New bolt - tensioning pulley 531 0274 30

LuK AS Part No.: **531 0274 30**

Issued 12.2007

Fig. 1: 531 0274 30

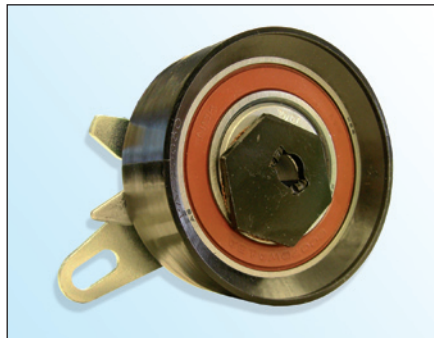
As part of the continuous development of our products and quality assurance, LuK AS now supplies a new bolt (fig. 3) with the tensioning pulley 531 0274 30.

- flat bolt head with Torx
- Bolt head \varnothing 18.5 mm
- Bolt grade 10.9
- Thread locking medium on the bolt
- Increased self-locking

LuK AS recommends replacing the original bolt (Fig. 2) with the supplied bolt.

Tightening torque: 20 ± 1,5 Nm
